CITY OF ALBUQUERQUE

Re: 4th and Montano Dental Office
5508 4th St., NW
Traffic Circulation Layout
Engineer's/Architect's Stamp dated 6-15-15 (F14-D055)

ENGINEER'S SEAL	4TH ST AND MONTANO DENTAL OFFICE	DRAWN BY DY
RONALD R. BOHANNAN NEW MEXICO PROFESSIONAL ENGINEER	TRAFFIC CIRCULATION LAYOUT	DATE 6/15/15
		2014099-TCL
		SHEET #
		C1
		JOB #
		2014099

**RE: 4TH AND MONTANO DENTAL OFFICE
5508 4TH ST., NW
TRAFFIC CIRCULATION LAYOUT (F14-D055)**

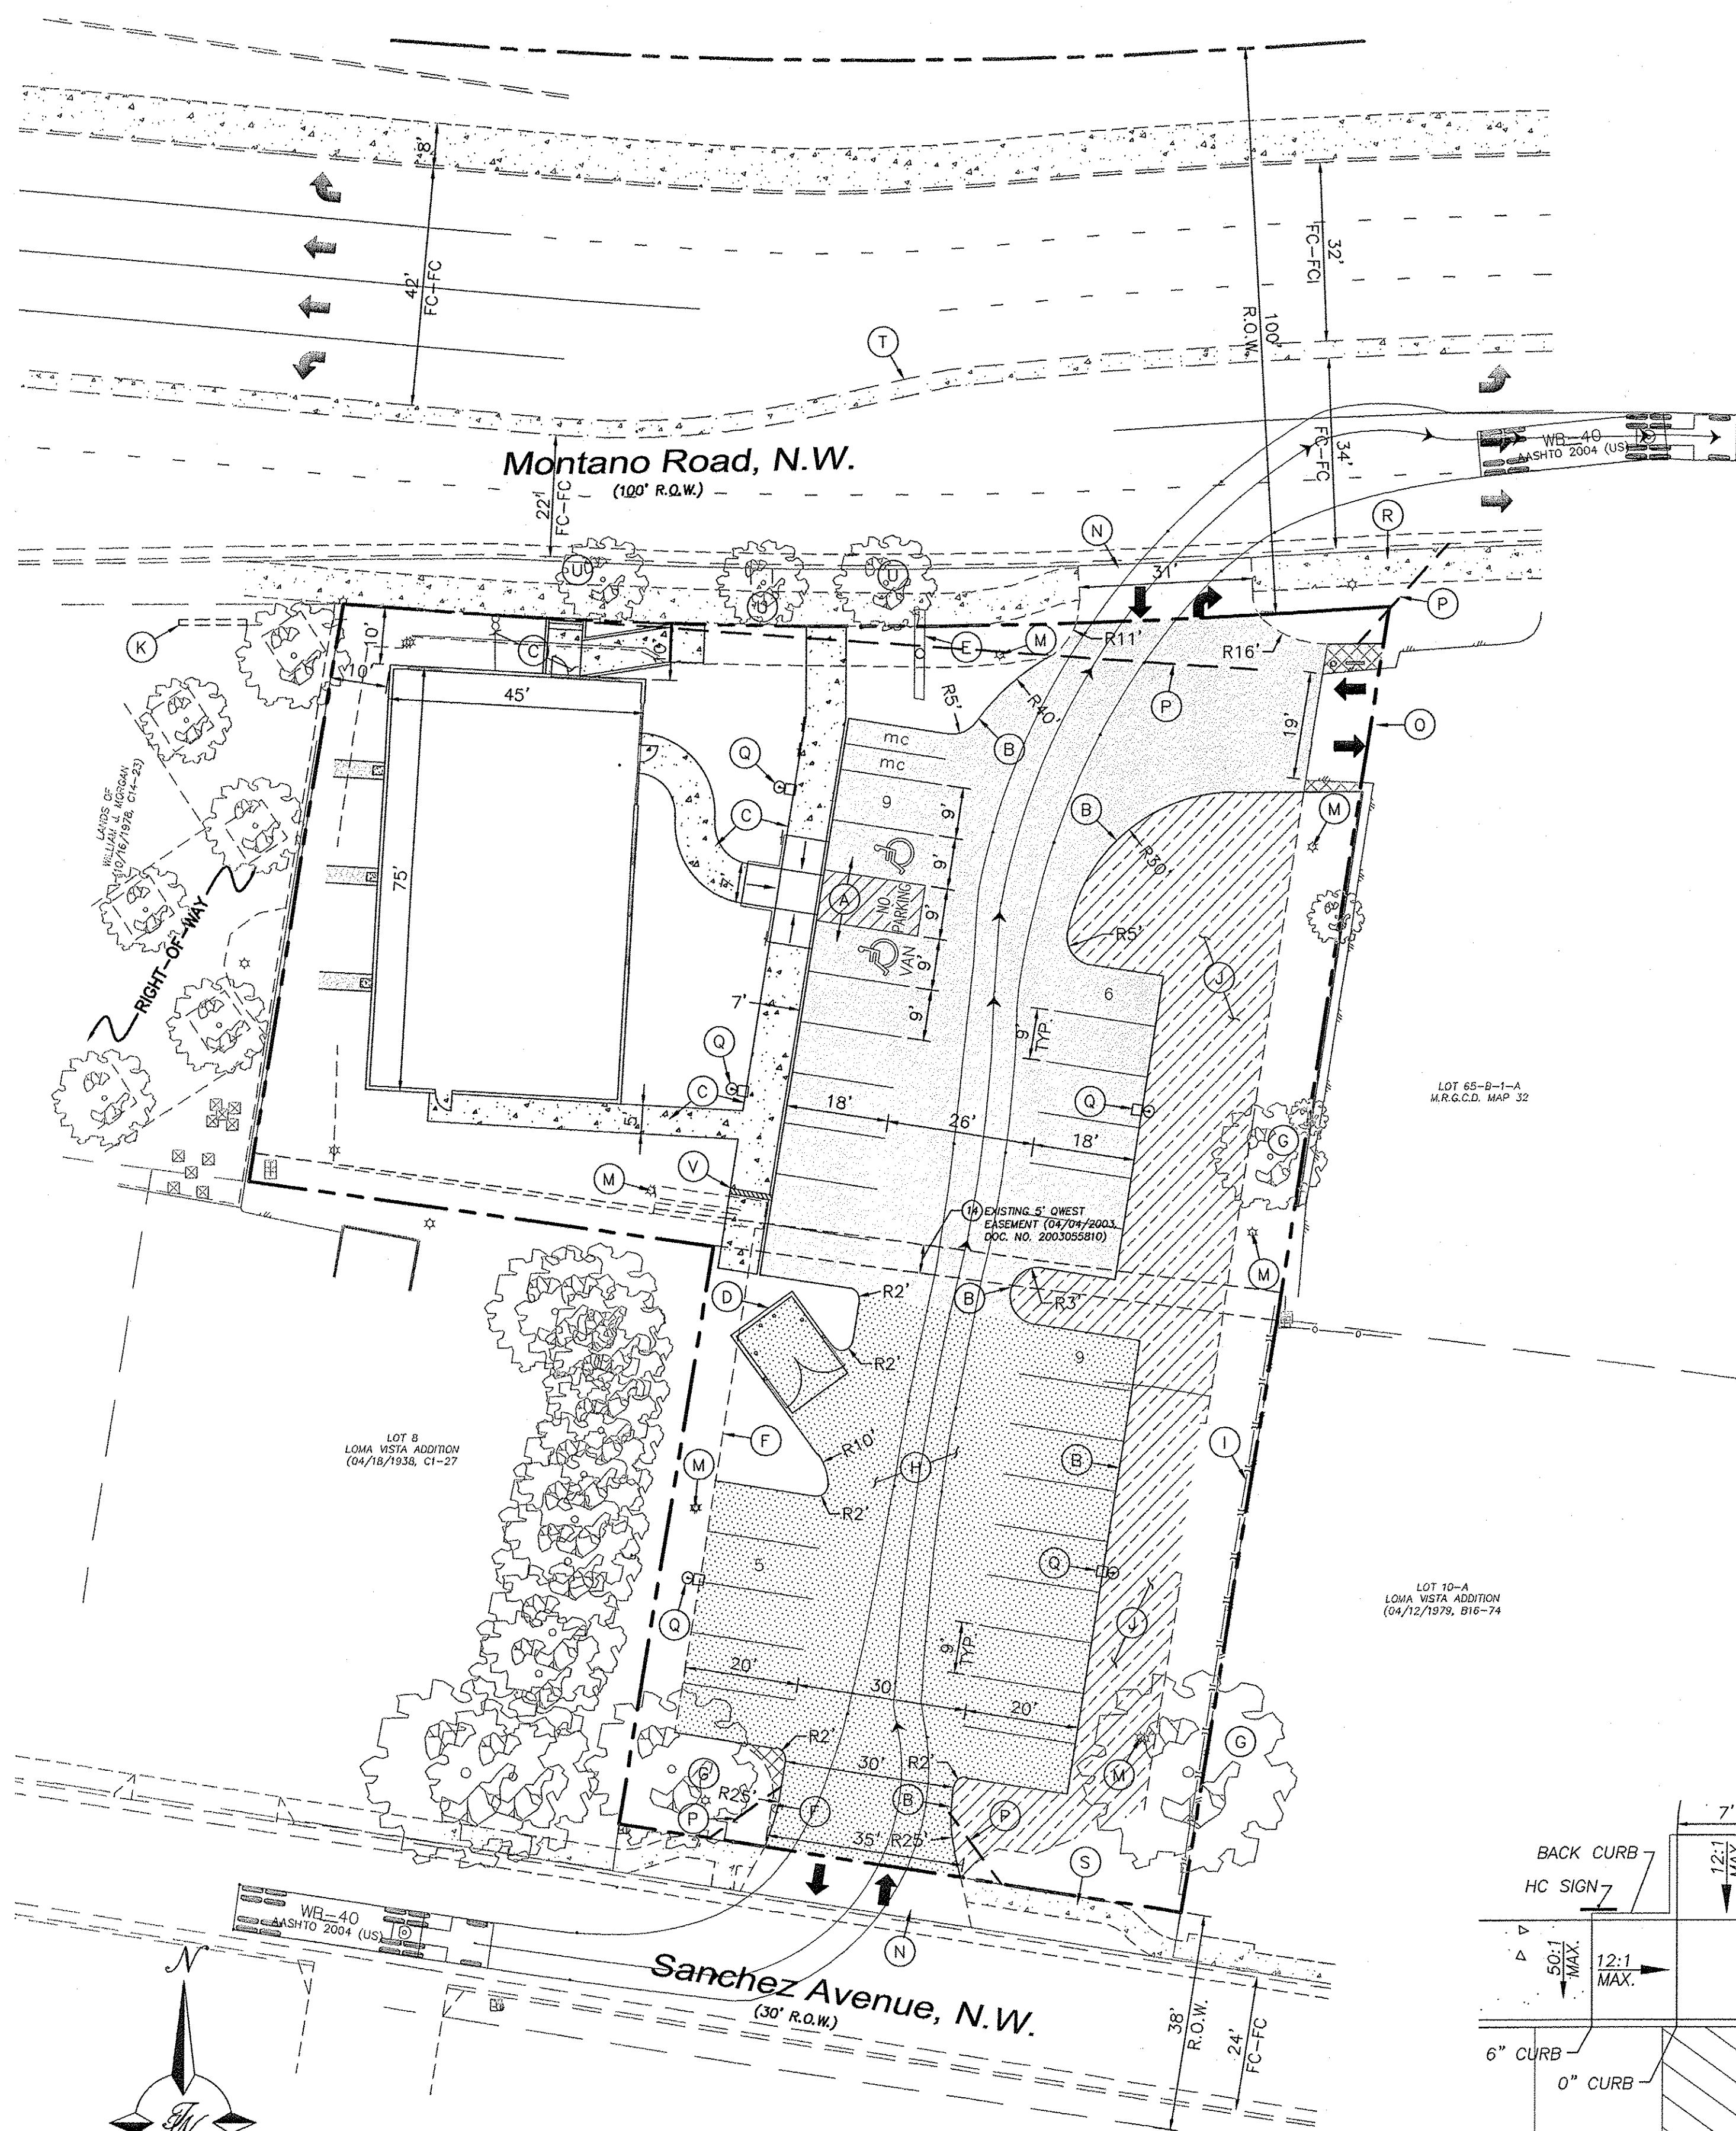
1. Clarify the extents of the current phase.
Response: The proposed building and all associated parking facilities will be constructed in a single phase after the existing structures are demolished. Portions of the existing pavement not in conflict with the proposed parking facility will remain as shown on sheet C1.

2. Identify all existing access easements and rights of way with dimensions.
Response: We identified all existing easements and added right of way dimensions to sheet C1.

3. Identify and dimension the existing right of way width, medians, sidewalks and curb cuts on Montano Rd., Sanchez Ave. and into the parcel to the east of the proposed building.

7. Show all drive aisle widths and radii.

8. Design delivery vehicle route needs to be shown

10. Please add the following note to the clear sight triangle: "Landscaping and signage will not interfere with clear sight requirements. Therefore, signs, walls, trees, and shrubbery between 3 and 8 feet tall (as measured from the gutter pan) will not be acceptable in this area."

Response: We indicated the dimensions of existing improvements within Montano Road and Sanchez Avenue on sheet C1; items are identified per the legend and keyed notes.

Response: We annotated all the drive aisle width dimensions and radii on sheet C1.

Response: We added the delivery vehicle route for a WB-40 design vehicle onto sheet C1.

Response: We added the note referenced above onto sheet C1 as Keyed Note P.

ACCESSIBLE PARKING LOT SIGN

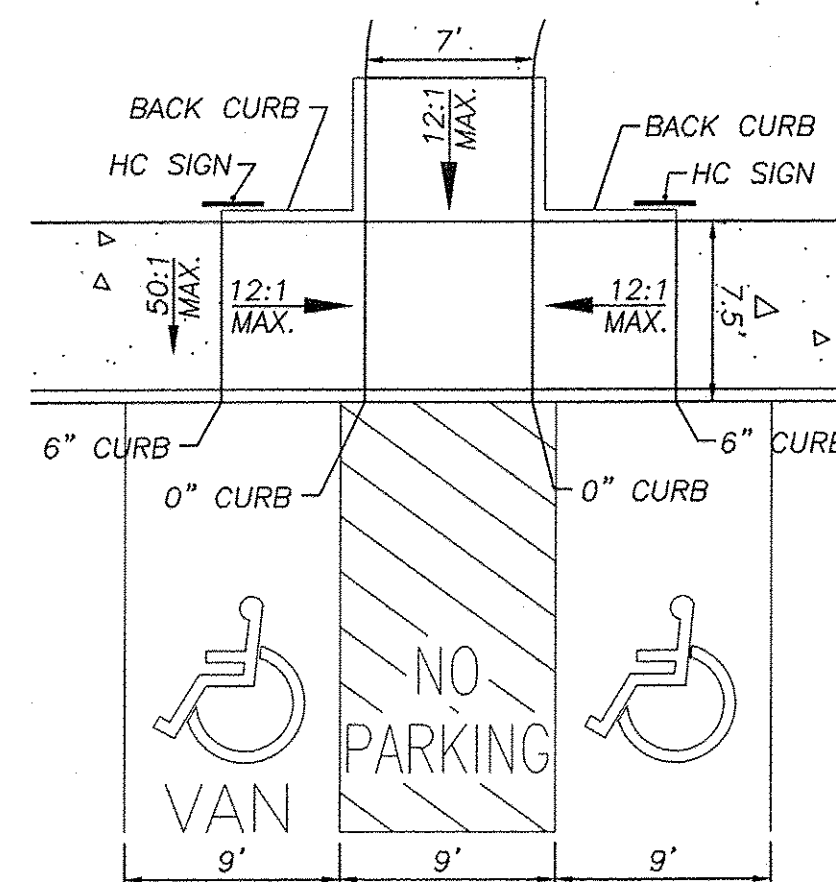
5. The ADA van accessible sign must have the required language per 66-7- 352.4C NMSA 1978 "Violators Are Subject to a Fine and/or Towing." Please show a detail of this signage.

Response: We updated the "Accessible Parking Lot Sign" detail on sheet C1 to include the language referenced above.
6. The ADA access aisle shall have the words "NO PARKNG" in capital letters, each of which shall be at least one foot high and at least two inches wide, placed at the rear of the

DETAIL 'A'
NTS

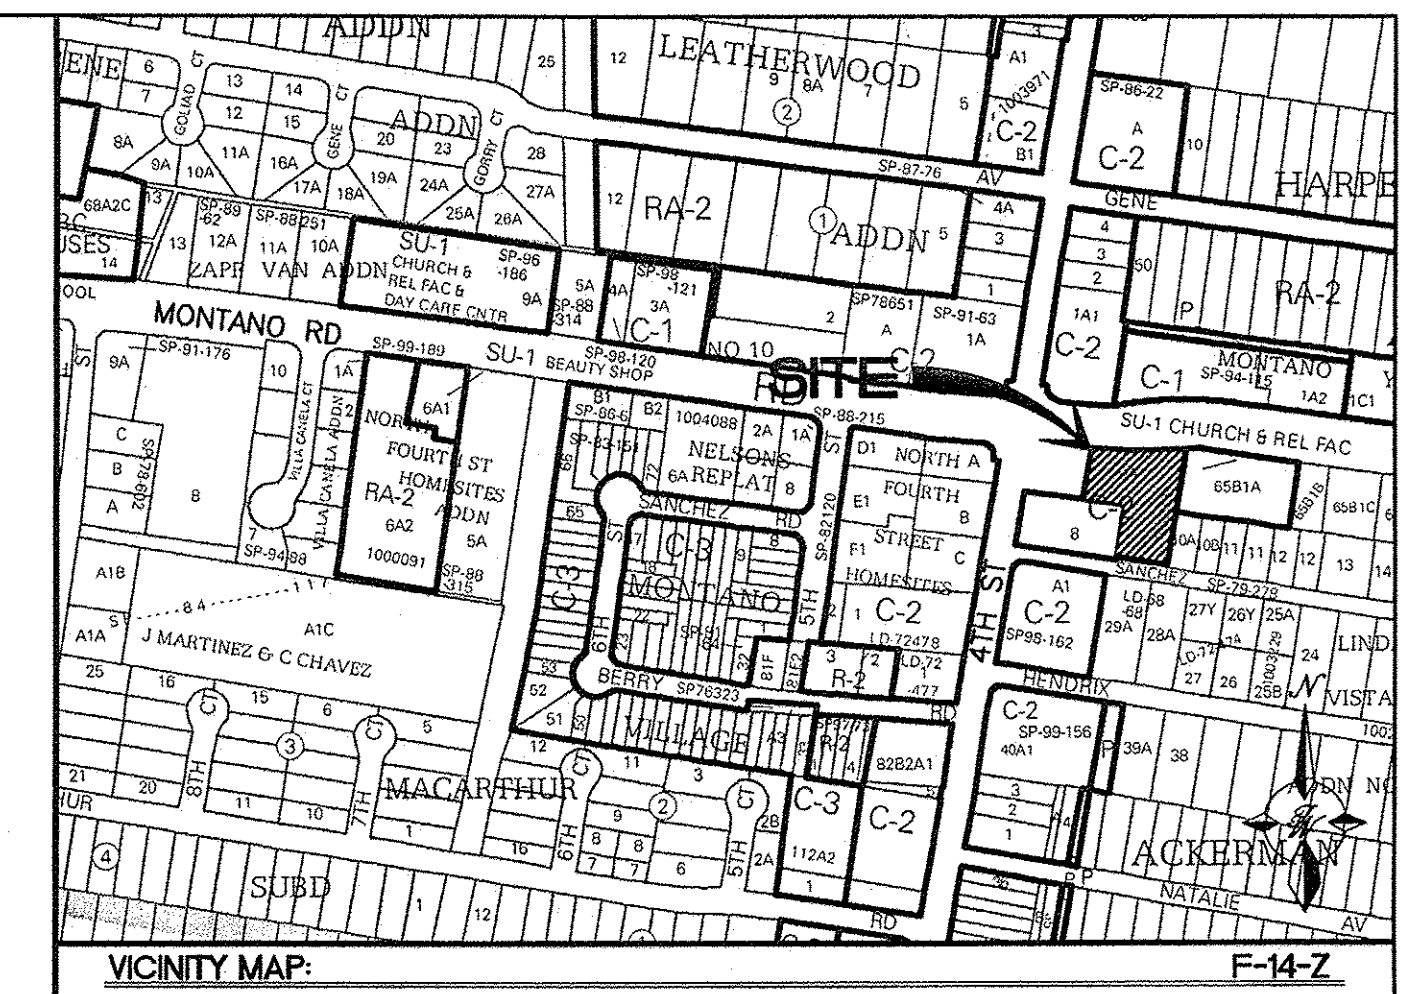
4. Please show a detail with dimensions and slope of the ADA pedestrian walkway transition from the ADA parking spaces.
Response: We added Detail "A" on sheet C1 to include the dimensions and slopes of the ADA pedestrian walkway transitions from the ADA parking spaces.

parking space so as to be close to where an adjacent vehicle's rear tire would be placed. (66-1-4.1.B NMSA 1978).

Response: We added Detail "A" on sheet C1 to include the "NO PARKING" pavement marking as described above.
